# SOUTHERN ENVIRONMENTAL LAW CENTER

February 4, 2020

RE: FAA Review of Proposed Spaceport Camden, Camden County, GA

**EXHIBIT A2-9. Range of Launch and Landing Azimuths Evaluated**

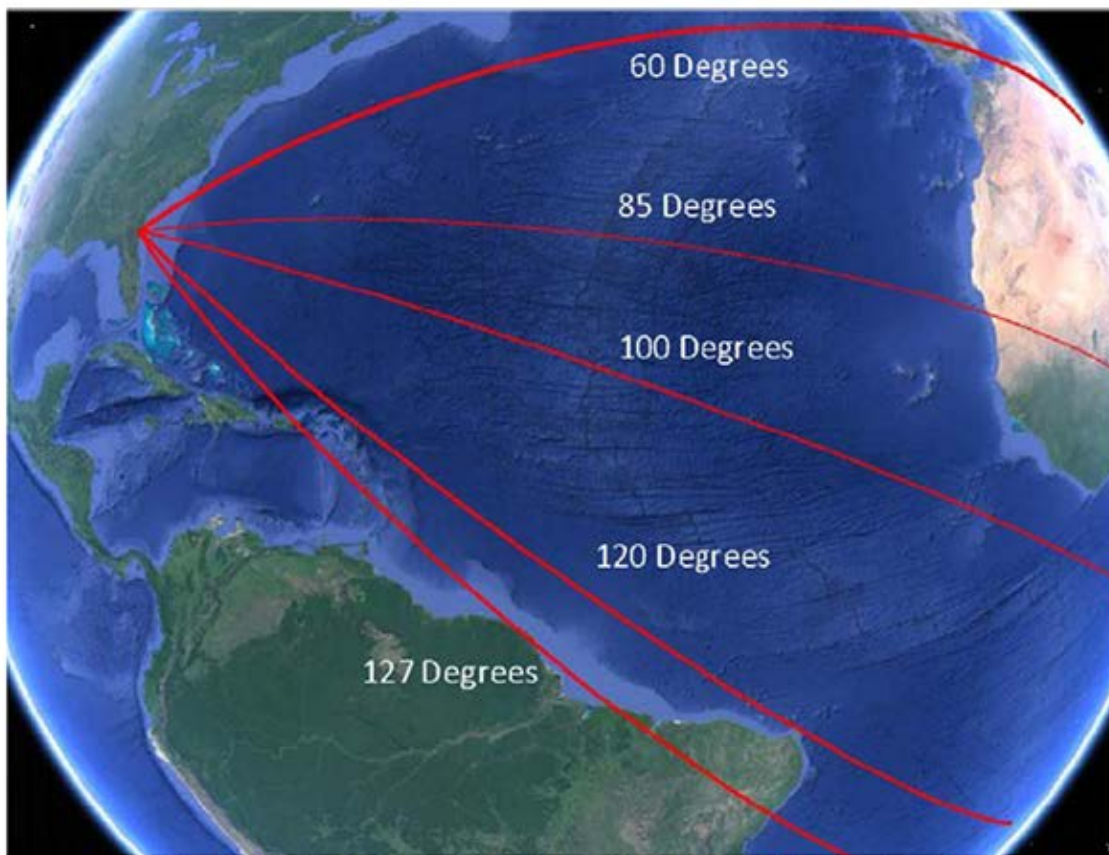
From Camden's application, here are the trajectories for the following azimuths. My analysis considers 85, 100 and 120 degrees – this would be 1E-06 for overflight of Africa.

Although Camden provides results for all of the azimuths, Camden only provided data for only the 100 deg azimuth. The POF used by Camden was 10% (30% OT, 30% LOT, 40% MFT).

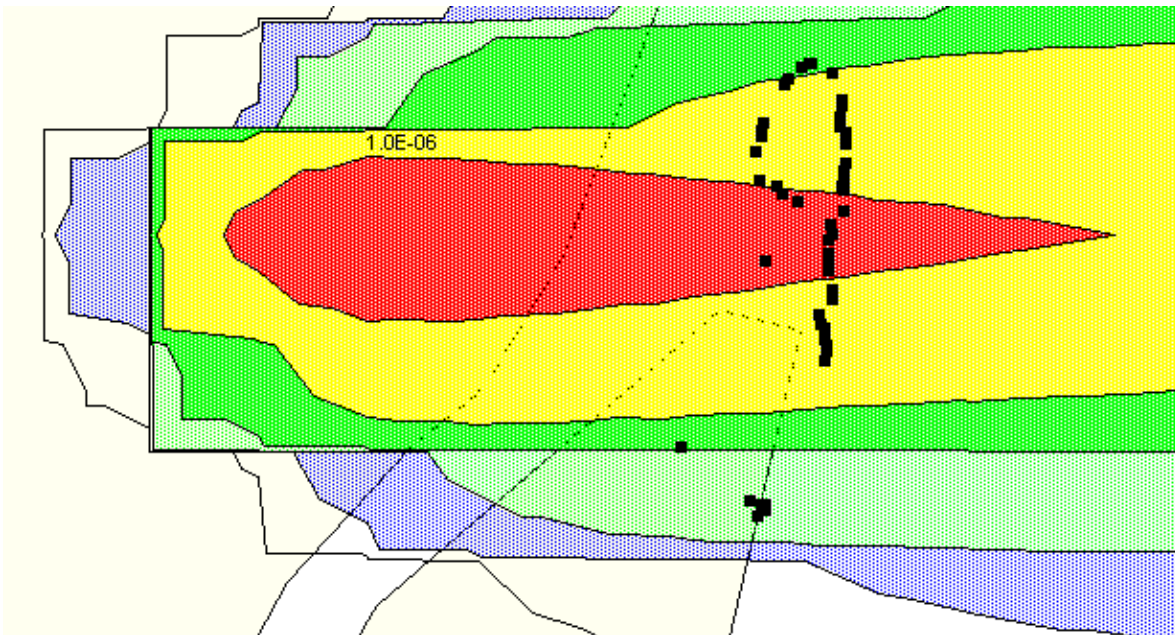
To assess population sensitivity with POF sensitivity, within the excel file refer to columns:

- I (Ec) and J (POF) 4.7% 1<sup>st</sup> stage POF (Original analysis)

- L (Ec) and M (New F9 POF) 1.6% 1<sup>st</sup> stage POF
- O (Ec) and P (Part 420 POF) 10% 1<sup>st</sup> stage POF (from Appendix C Part 420)
